LAKE PONTCHARTRAIN, LOUISIANA AND VICINITY

BAYOU DUPRE CONTROL STRUCTURE

PERIODIC INSPECTION REPORT NO. 4

LS2K
LMVED-GS (LMKED-DG/1 Dec 86) 3rd End Mr. Cave/ac/5897
SUBJECT: Lake Ponchartrain, Louisiana and Vicinity, Chalmette
Area Plan, Bayou Dupre Control Structure,
Periodic Inspection Report No. 4

PHOTO NO. 3- Note misalignment of concrete sheetpile panels that occurred during construction.

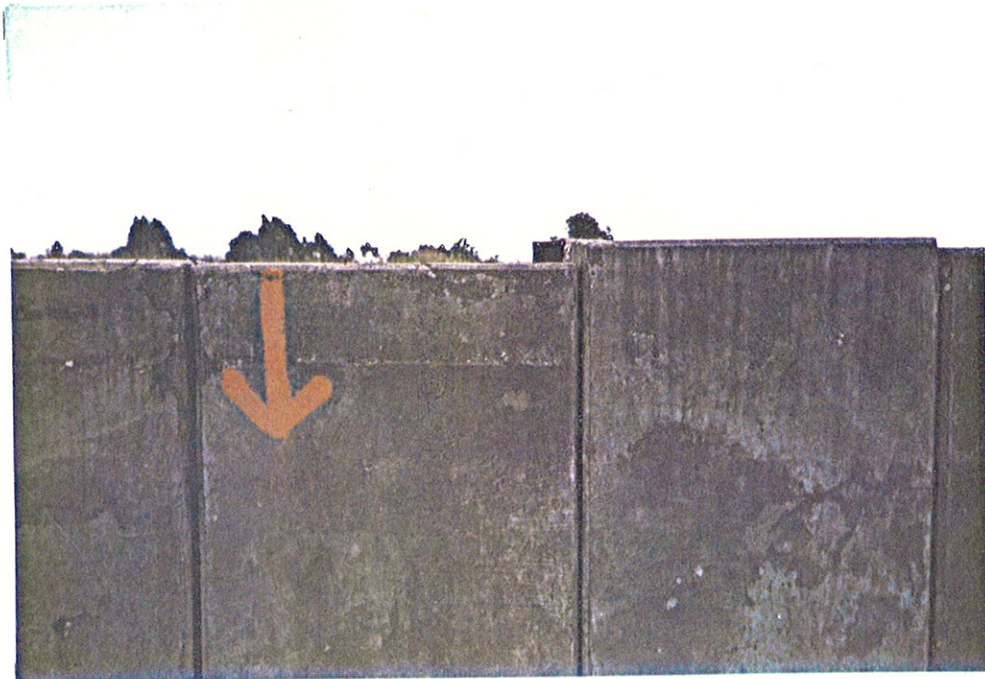
c. Para 5-03 a (3) (b) and Photo No. 3. The caption for Photo No. 3 should be changed to read, "Note misalignment of concrete sheet pile panels that occurred during construction." The caption as presently written could be misleading concerning the lateral stability of the wall. Photograph No. 4 correctly describes the vertical differential movement that has occurred over several years at this structure. Paragraph 5-03d(3)(b) of the report text should also be revised to be consistent with the caption.

c. Para 5-03 a(3)(b) and Photo No. 3. We concur. Both the caption for Photo No. 3 and Paragraph 5-03 (3)(b) have been revised to indicate that the misalignment of the concrete sheetpile panels occurred during construction. The caption for Photo No. 4 has been revised to indicate that the differential movement shown in the photograph is vertical.

SETTLEMENT REFERENCE MARKS
DIFFERENTIAL SETTLEMENT CHART

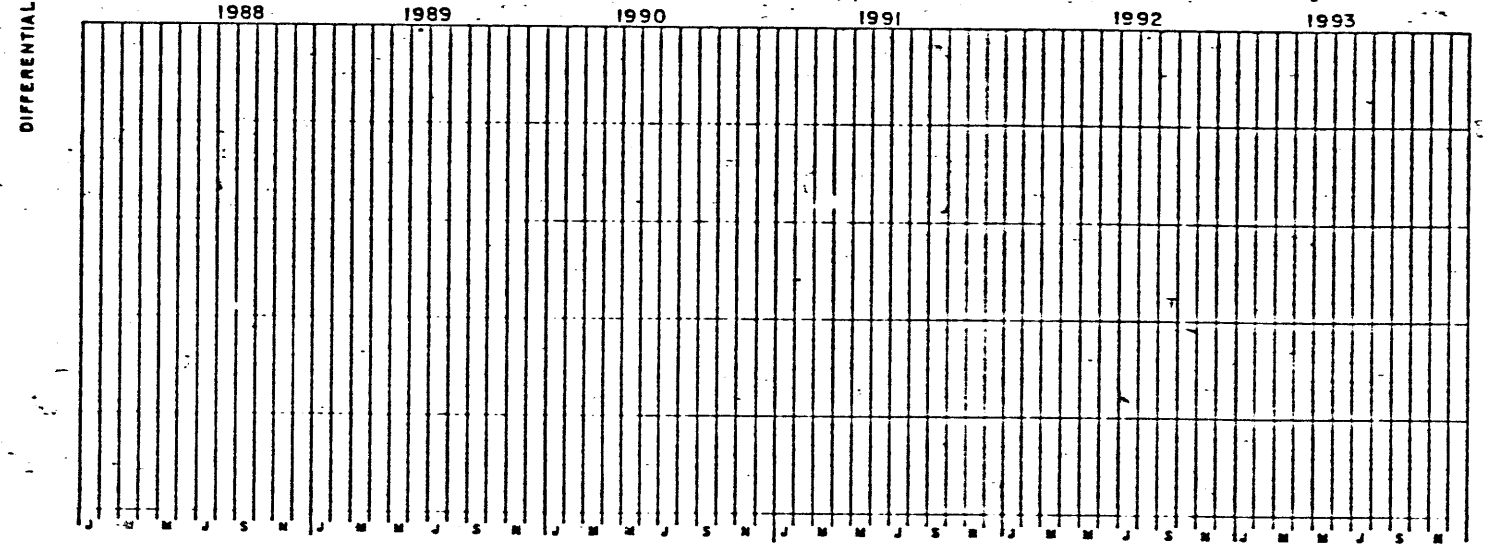
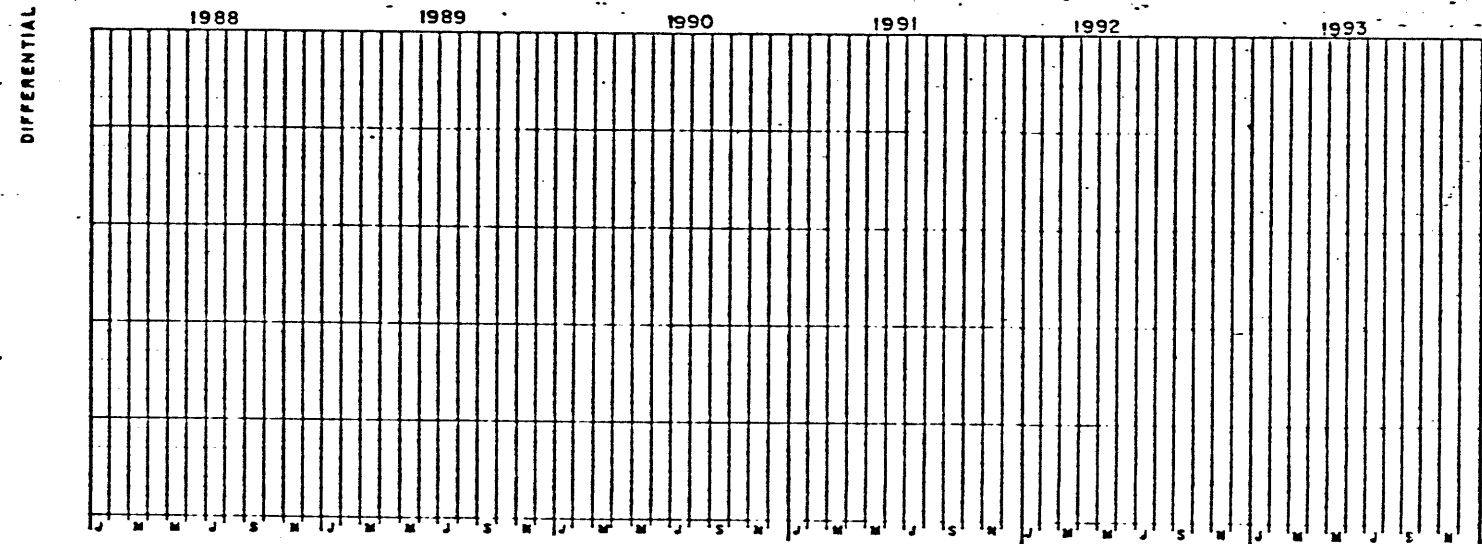
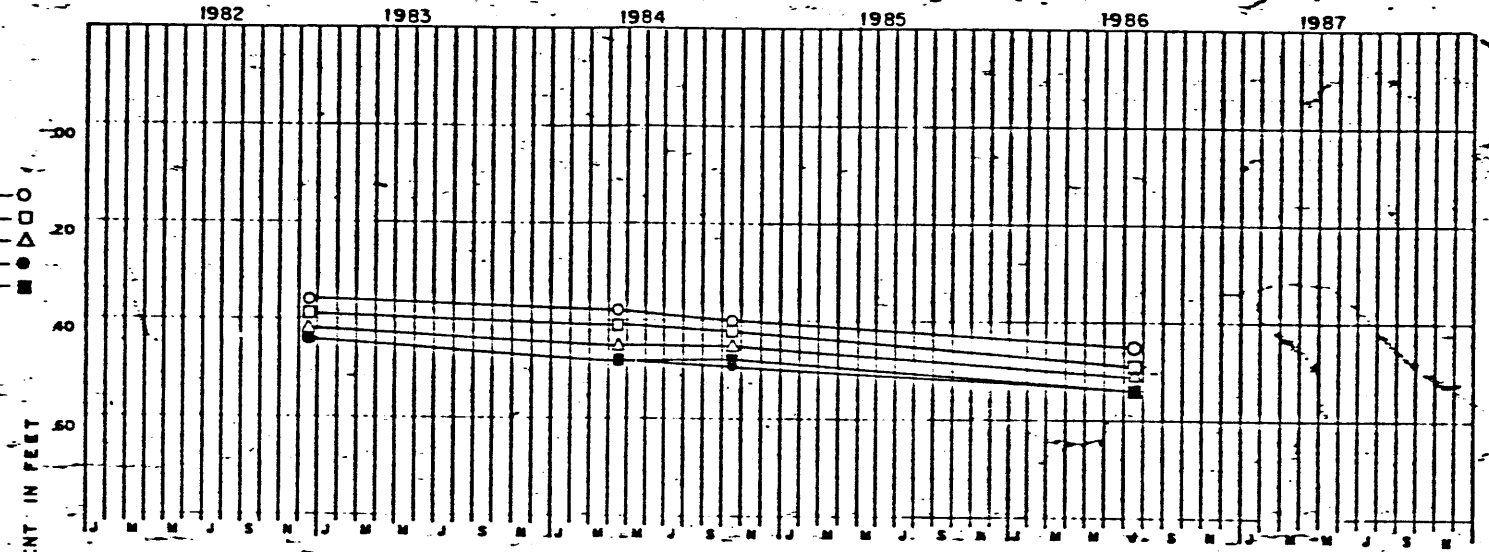
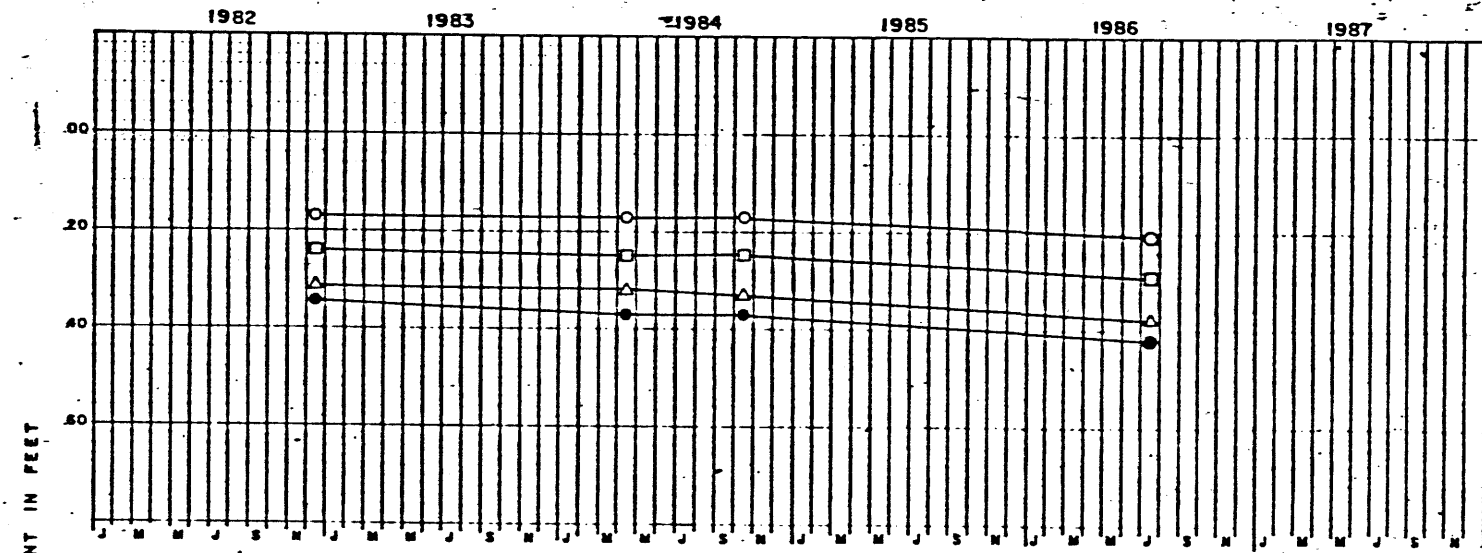
a. Para 4-03 a. and Plates 20 and 21. This paragraph should give a better explanation of the observed settlement. It should be noted that more fill has been placed in levee adjacent to the east sheetpile wall than the levee adjacent to the west sheetpile wall which explains the difference in total settlement between these two walls. The paragraph should point out that additional fill was placed near the east sheetpile wall in 1977 and 1982, and this additional fill placement caused additional settlement of the wall. Without these explanations, the reader gets the misleading impression that the same amount of fill placement has caused more settlement and a faster rate of settlement of the east wall than the west wall. It would be beneficial if the dates of the additional fill placements were noted on the plates.

a. Para 4-03 a. and Plates 20 and 21. We concur. Paragraph 4-03 a. has been rewritten to better explain why the amount and rate of settlement of the east concrete sheetpile wall exceeds that of the west concrete sheetpile wall. The new paragraph points out that additional fill was placed near the east wall on two separate occasions; however, our records indicate that the fill was placed in 1978 and 1983, and not 1977 and 1982 as the first endorsement indicates. The dates of the additional fill placements have also been noted on Plates 20 and 21.
